**RE: Overture Senior Active Adult
6410 Palomas Ave NE
Grading and Drainage Plan
Engineer's Stamp Date: 09/20/18
Hydrology File: D18D056A**

Based upon the information provided in your submittal received 09/21/2018, the Grading and Drainage Plan **is not** approved for Building Permit and Grading Permit. The following comments need to be addressed for approval of the above referenced project:

ENGINEER'S SEAL JOEL D. HERNANDEZ P.E. #17893	OVERTURE SENIOR ACTIVE ADULT GRADING AND DRAINAGE PLAN TIERRA WEST, LLC 5571 MIDWAY PARK PLACE NE ALBUQUERQUE, NM 87109 (505) 858-3100 www.tierrawestllc.com	DRAWN BY DY DATE 9/20/18 2017086-GRB
		SHEET # C2 JOB # 2017086

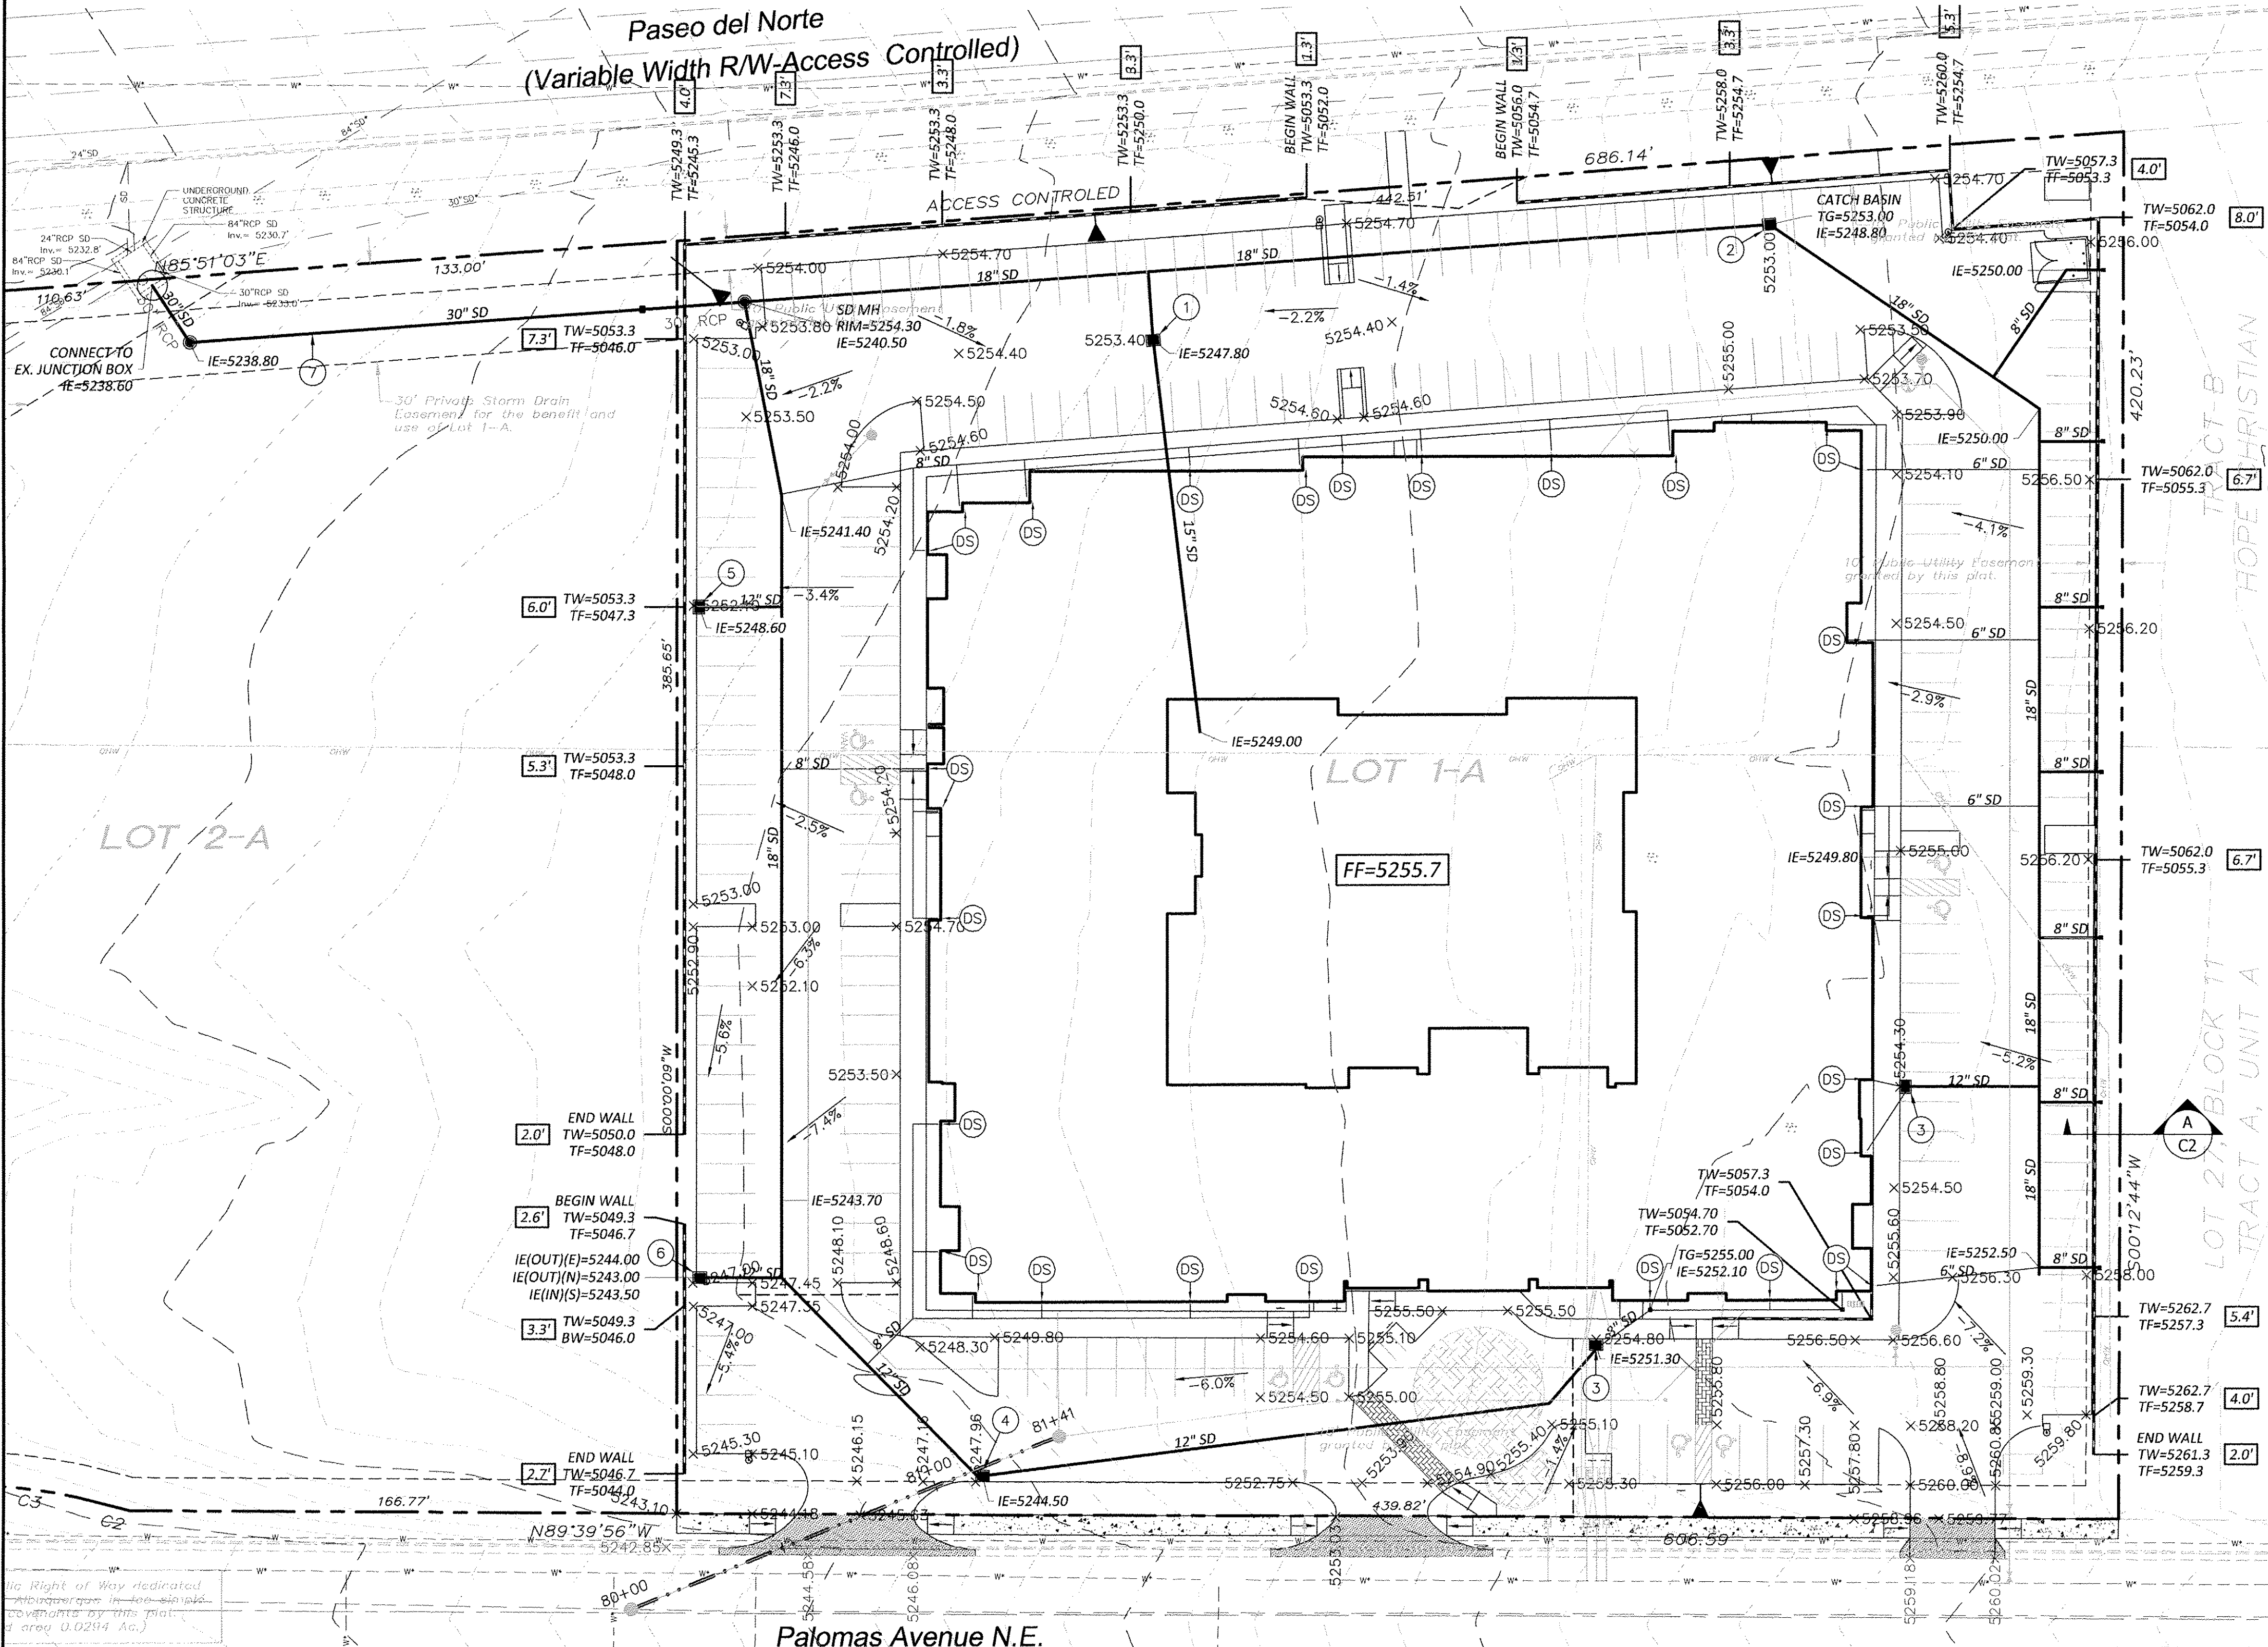
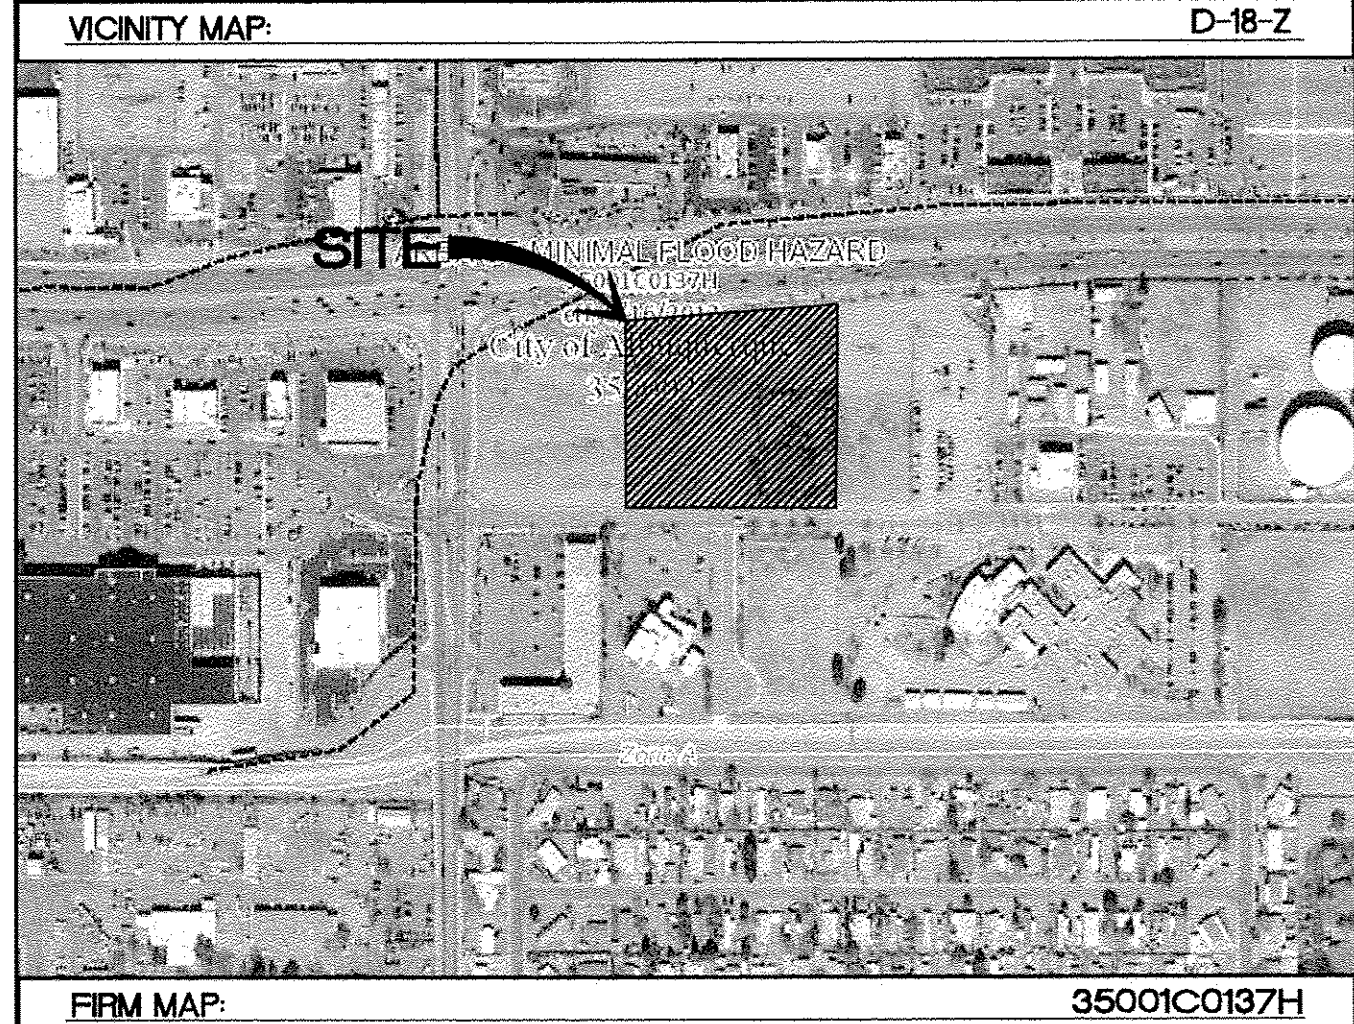
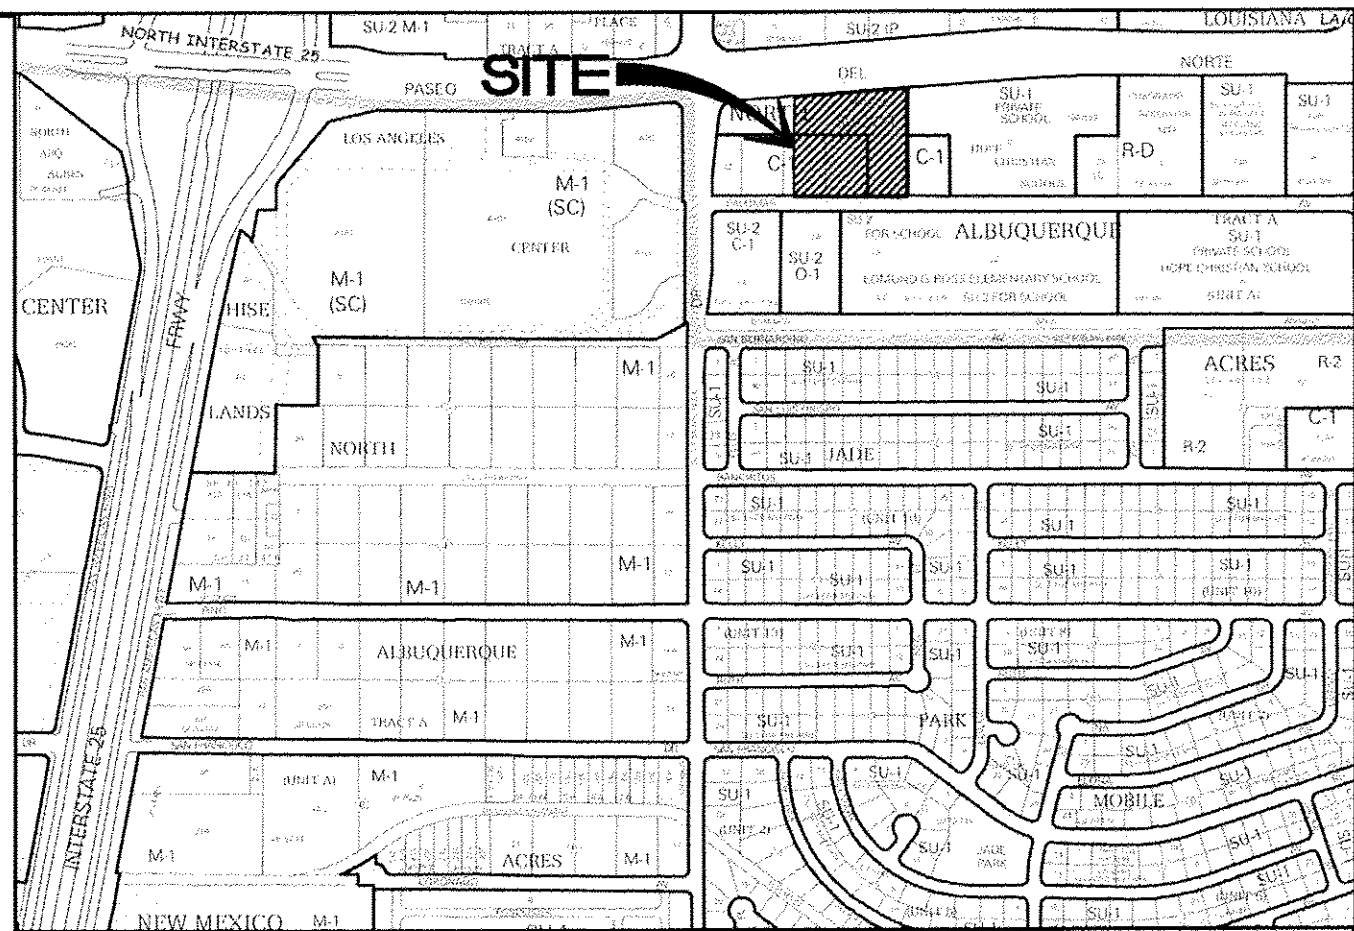
1. The site currently shows more than 1 acre of disturbance is being proposed. An Erosion and Sediment Control Plan is required and has to be submitted to the storm water quality engineer (Curtis Cherne, PE, ccherne@cabq.gov). Hydrology's approval for Grading or Building Permit will not be given until the submittal of the ESC Plan.
2. Please provide the FIRM Map's effective date.
3. Please provide the benchmark information for the survey contour information provided.
4. Please provide a section of the proposed retaining wall along Paseo del Norte near the Northwest corner of the site and a section of the proposed retaining wall along the Western property line.
5. Please add a note requesting a waiver for the first flush volume requirement. Also add a note stating, "The required first flush volume for the 142,764.70 SF of impervious cover is 4,045 CF."
